Response to Anonymous Reviewer #2

Authors' response to Reviewer #2 comments on "Evaluation of the uncertainty of the spectral UV irradiance measured by double- and single-monochromator Brewer spectroradiometers".

Figure 4. Global irradiance ratio to the QASUME recorded on 13 September at 14:00 UTC. (a) First group (double Brewers with cosine correction). (b) Second group (two single and three double Brewers with no cosine correction implemented).

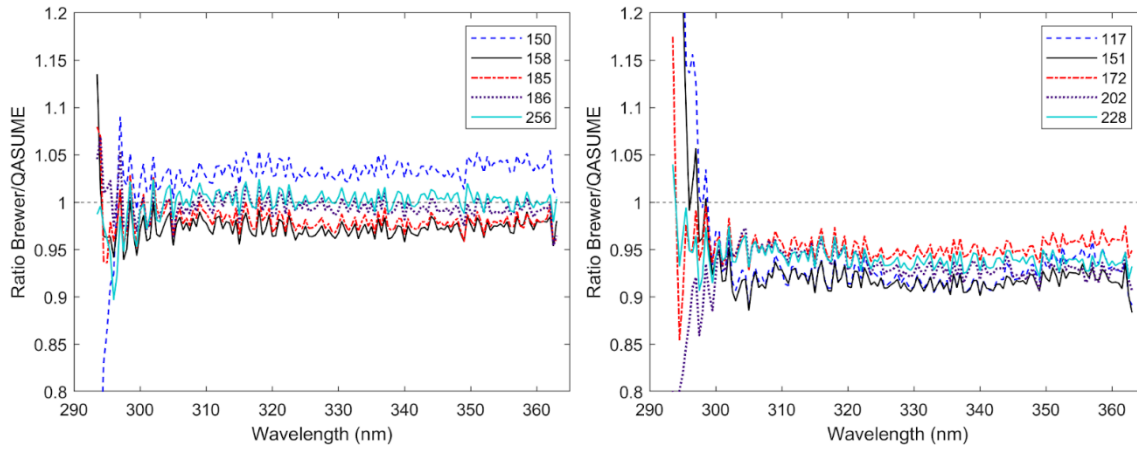
(1) However, I think some issues need to be clarified before the manuscript can be published: There are already WMO-GAW guidelines for quality control (QC) and quality assurance (QA) of UV measurements, which are WMO-GAW Reports No. 146 (Webb et al., 2003, Quality assurance in monitoring Solar UV radiation: the state of the art) and No. 126 (Webb et al., 1998, Guidelines for site quality control of UV monitoring). I think you should discuss more in the Introduction how your study reflects the guidelines of these reports and refer to the "deductive" and "inductive" methods for QA introduced in Webb et al., 2003. You should also refer more closely to Webb et al., 1998. In addition, I think you should consider showing and discussing your uncertainty estimate and the results of the intercomparison campaign. You have the ideal setup of having the QASUME intercomparison results from the El Arenosillo campaign. Thus, you could compare the results of your "deductive" method with the results of the "inductive" method.

(1) Another concern is the uncertainty associated with cosine correction. I don't understand why you get such higher uncertainties in measurements that are cosine corrected compared to those

that are not. Shouldn't it be the other way around? If the cosine correction is in the range of 5 to 10%, then the measurements missing that correction should be at least that far off and have higher uncertainties? And, as mentioned in the specific comments, please include the information of which part of the cosine correction (angular response characterization, dir/diff ratio determination...?) has the largest uncertainty. Maybe I missed something: please explain this more clearly.

Finally, a section regarding the uncertainty ratio between the QASUME and the instruments has been added to the Results section. A new figure and table have been added to the manuscript as follows:

Figure 4 shows the effectiveness of the cosine correction, since Brewers with such correction implemented (Fig. 4a) report irradiances more similar to the one measured by the QASUME. Nevertheless, the agreement between all Brewer spectrophotometers and the QASUME is within 10 % for wavelengths above 310 nm.

(2) It is important to differentiate between an error and the uncertainty associated with its correction. If the spectral irradiance measured is not corrected for the instrument's cosine error, it will have a larger error (see the Figure 4 in the response to the previous comment). In fact, the comparison campaign showed that correcting the Brewer cosine error improved the global irradiance ratio to the QASUME (Hülse, 2023). On the other hand, the calculation of the cosine correction factor has an uncertainty, which needs to be taken into account in the uncertainty analysis. Nevertheless, this uncertainty can only be determined if the cosine error is characterised. That is why the Brewers with no cosine correction have smaller uncertainties, because this uncertainty source could not be considered in their evaluation. As a result, the uncertainty evaluation of these Brewers is limited, as the cosine error is not included in the analysis.
